Re: HVO Continuation Project (SSD-11826681 and SSD-11826621)

HVO Continuation Project – Response to EPA request
for additional information relating to noise

Subject: HVO Continuation Project - EPA comments on Response to Submissions relating to noise

HVO Continuation Project – Response to EPA request
for additional information relating to air quality

Figure 1 Potentially highest impacted receptors based on modelled 24-hour average PM₁₀ concentrations

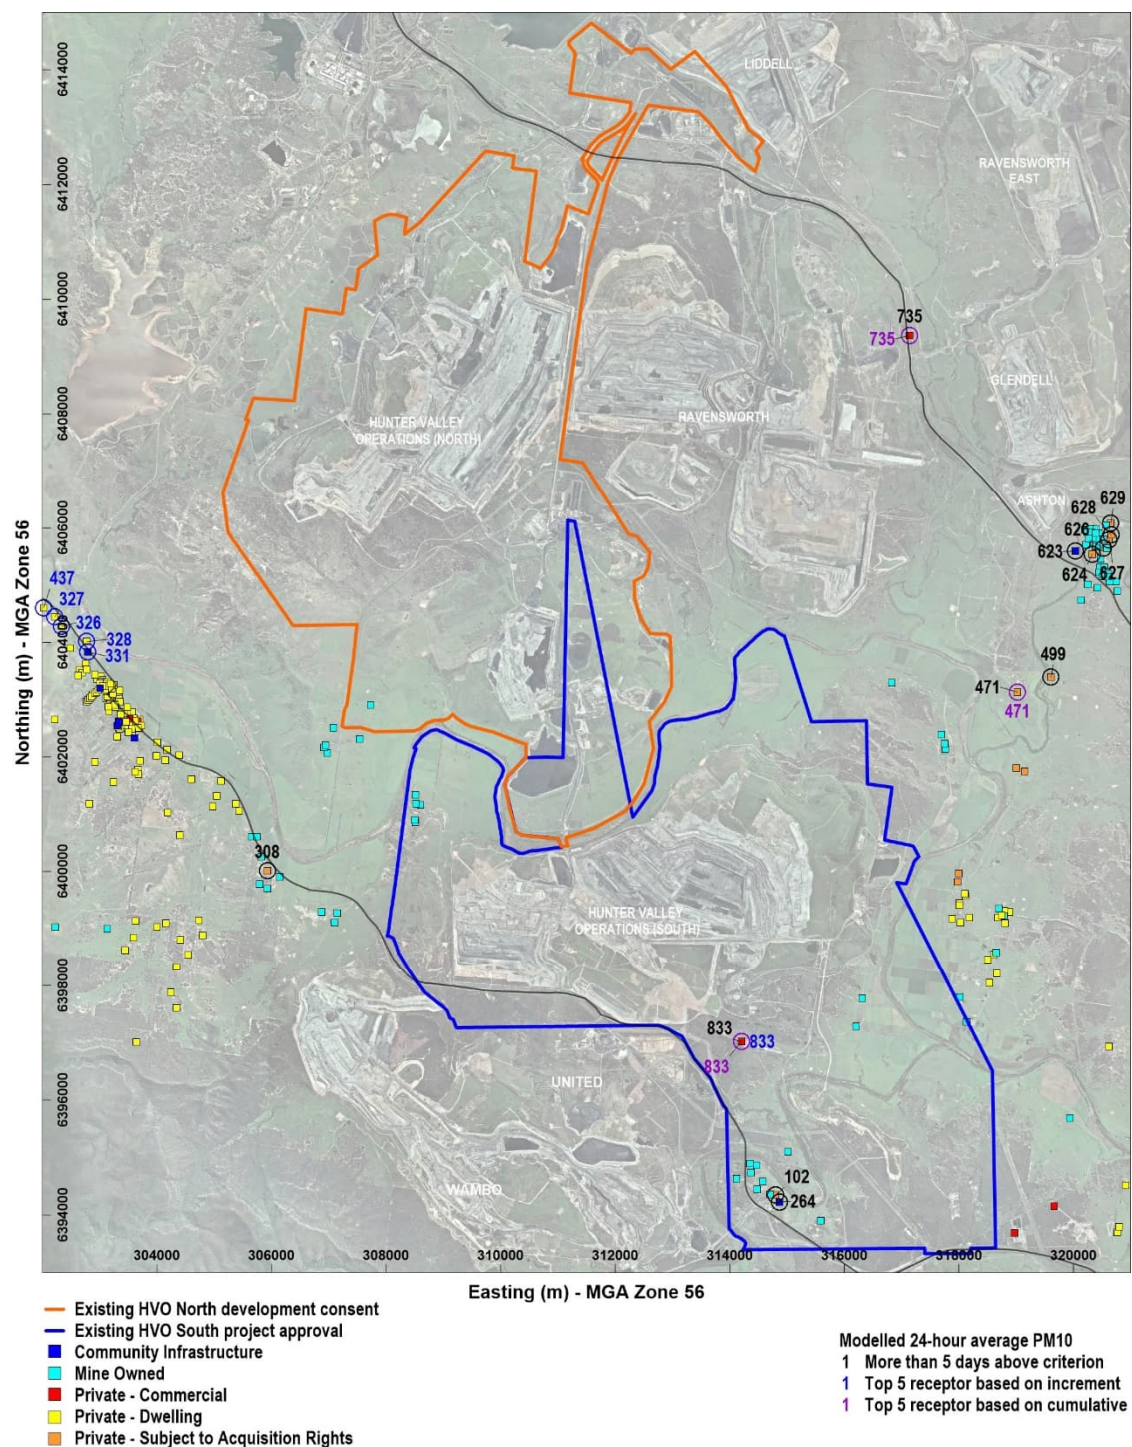
1a) A list of receptors ranked by the highest predicted cumulative impacts and predicted incremental impacts for all modelling scenarios included in the original Air Quality Impact Assessment (AQIA).

The requested lists of receptors have been presented graphically in Figure 1 showing the top 5 receptors based on Project increment, the top 5 receptors based on cumulative concentrations, or where the modelling indicates more than 5 days above the 24-hour average PM₁₀ assessment criterion. In some cases (e.g. 596) the receptors do not appear on Figure 1 as they are at significant distances from HVO and the air quality outcomes were primarily influenced by other mining operations.

- Based on cumulative impacts (shown labelled in purple in Figure 1):
 - Receptor 735 relates to an industrial workplace (owned by Daracon Mining Pty Ltd), located adjacent to the New England Highway to the east of the Project Area. This is excluded on the basis of it being a mining-related receptor.
 - Receptor 833 is the Hunter Valley Gliding Club which is only occupied periodically for short periods of time.
 - Receptors 596, 862 and 471 are private dwellings that are subject to acquisition rights under other mining operations approvals as detailed below. There are significant mining operations closer to those receptors than HVO.
 - 596: Rixs Creek North PA08_0102 (air quality and noise), Integra Underground PA08_0101 (noise).
 - 862: Rixs Creek North PA08_0102 (noise).
 - 471: Ashton DA309-11-2001-I (air quality and noise); Ravensworth Operations DA 09_0176 (air quality)

- Based on incremental impacts from the Project (shown labelled in blue in Figure 1):
 - Receptors 326, 327, 328 and 437 are private sensitive receptors in Jerrys Plains, that are not subject to any acquisition rights.

- Receptor 331 is a pony club shed in Jerrys Plains which is only occupied periodically for short periods of time.
 - Receptor 833 is the Hunter Valley Gliding Club which is only occupied periodically for short periods of time.

- Based on more than 5 days modelled above the 24-hour average PM₁₀ assessment criterion:
 - Receptor 623 is the deconsecrated St Clements Church in Camberwell which is rarely occupied. A sensitive receptor is defined by the EPA as “a location where people are likely to work or reside; this may include a dwelling, school, hospital, office or public recreational area” and interpreted as places of near continuous occupation (e.g. with likely daily occupation).

Figure 2 Modelled 24-hour average PM₁₀ concentrations at Receptor 328

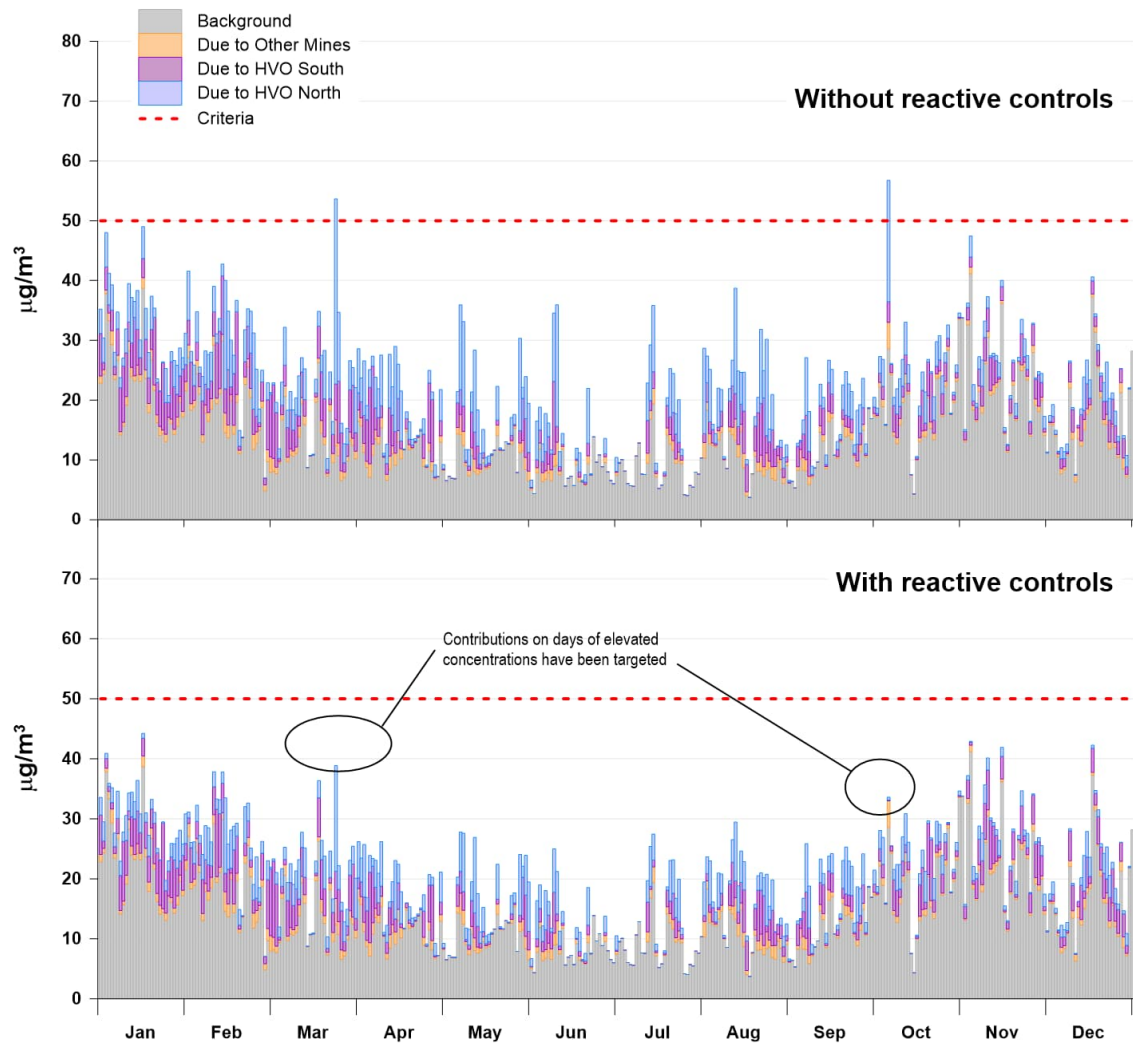
1b) Based on the analysis of information in (a) above, revise the analysis of results for the 'reactive control' modelling scenario to clearly demonstrate that the proposed trigger levels and implementation of reactive measures are not predicted to result in additional exceedances of all relevant impact assessment criteria at any of the receptors.

An additional receptor (328) has been investigated based on the analysis above. Receptor 328 was selected as the modelling indicated that this receptor may experience the highest incremental 24-hour average PM₁₀ contributions from the Project of all private dwellings not subject to air quality acquisition rights. Outcomes for this receptor will be similar to outcomes for the surrounding receptors in Jerrys Plains.

Figure 2 shows the modelled 24-hour average PM₁₀ concentrations at receptor 328. It can be seen from these results that the implementation of reactive controls (in response to elevated off-site air quality levels) can be effective at reducing the Project contribution to 24-hour average PM₁₀ concentrations in a representative meteorological year, and that the Project will not cause additional exceedances of the impact assessment criteria. By nature, the reactive controls primarily address days when the PM₁₀ concentrations may be approaching or exceeding the 24-hour average criterion. These results do not reflect any similar reactive controls that are employed at other mining operations so the cumulative results can be considered as worst case.

The modelling shows that reactive controls will be effective for minimising the potential of the Project to cause exceedances of the EPA's air quality assessment criteria. It is also noted that the modelling does not show any exceedances of the air quality criteria in HVO's existing development consents. HVO is committed to refining their Trigger Action Response Plan (TARP), where necessary, to maintain compliance at all sensitive receptors.

Figure 3 Relationships between PM_{2.5} and PM₁₀ concentrations from data collected at Kelly in 2023

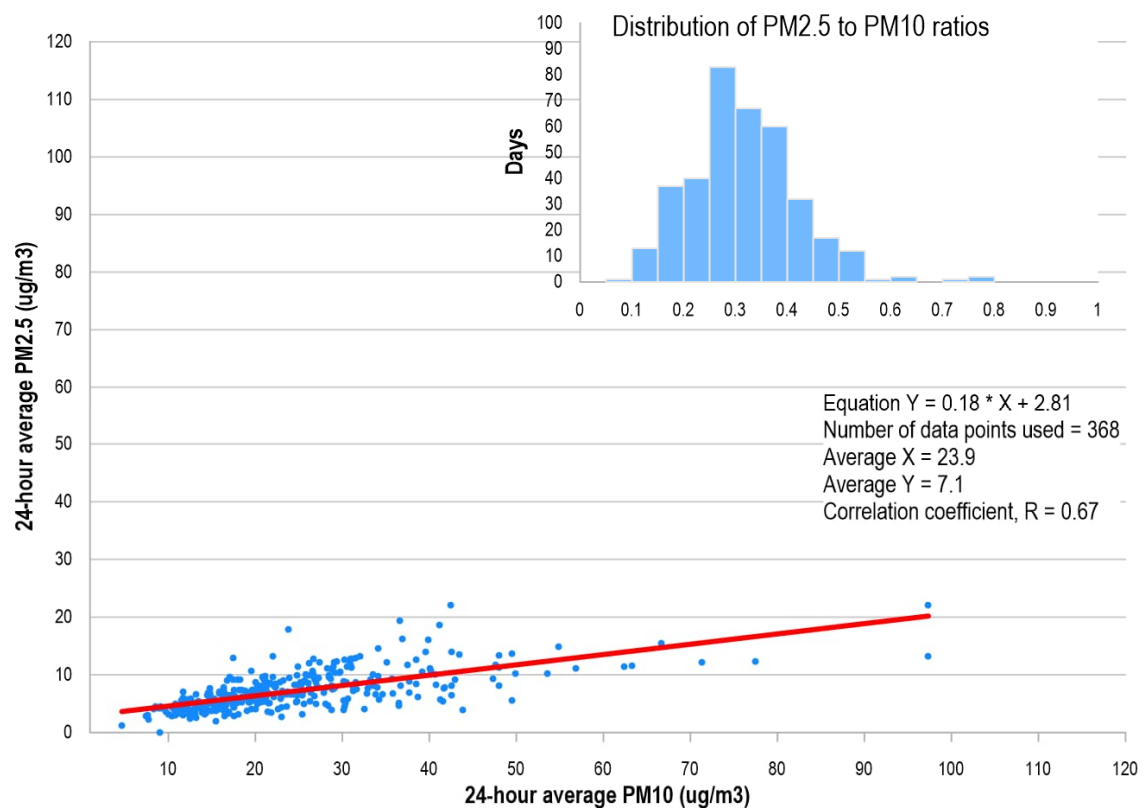
2a) Additional analysis to demonstrate that the adopted PM_{2.5}/PM₁₀ annual ratio is representative of the range of anticipated hourly PM_{2.5}/PM₁₀ ratios

Figure 3 provides some additional analysis of PM_{2.5} to PM₁₀ ratios based on 24-hour average co-located PM₁₀ and PM_{2.5} monitors at 'Kelly' in 2023. Average PM_{2.5} to PM₁₀ ratios were calculated to be 32% with a 70th percentile (Victorian EPA approach) of 36%. A ratio of 37% was used for the Project. The data from Figure 3 show a reasonable correlation between PM_{2.5} and PM₁₀ concentrations and no alternative (i.e. non-linear) relationships are evident. It is therefore maintained that the approach adopted for the AQIA provides for reasonable and conservative estimates of background PM_{2.5} concentrations for the purposes of assessment and for determining potential risks of PM_{2.5} impacts.
